EDMS NO. 1973224	REV. 0.2	VALIDITY DRAFT
----------------------------	--------------------	--------------------------

REFERENCE LHC-TC-EC-0015

ENGINEERING CHANGE REQUEST

Upgrade Of The Crystal Collimation Test Stand in IR7

Figure 1 — 3D view of the horizontal goniometer setup: the crystal can be inserted into the beam only when the C-shape replacement chamber is moved out (on the bottom in the figure). The 3D reference corresponding to the crystal collimator in the horizontal configuration is the ST0563346_01.

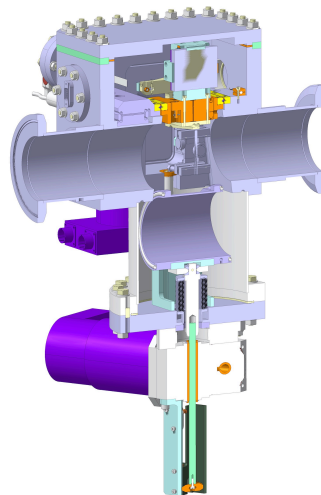
At this stage, we assume that the design of the TCPC assembly remains will very similar to the presently installed hardware, see Figure 1. It will still rely on a movable replacement chamber that allows inserting the crystal close to the beam only in its "out" position. In standard operation for proton beams, this replacement chamber will be in its "in" position and hide the crystal from the circulating beam. This is optimum for impedance optimization in the proton operations when crystals are not used.

As a design requirement, possible design modifications from the present hardware must fit into the present installation slots, so that the present assemblies can be replaced with minor changes (as for example it was described in [4]). At this stage, we also assume that no additional controls cabling is required and that the present ones will be used in case new TCPCs are installed.

The detailed description of which one(s) of the 4 TCPCs shall be changed in LS2 will follow after the experiments' results in the LHC, through an update of this document. At this stage, we assume conservatively – for resource estimates – that all the 4 TCPCs shall be replaced.
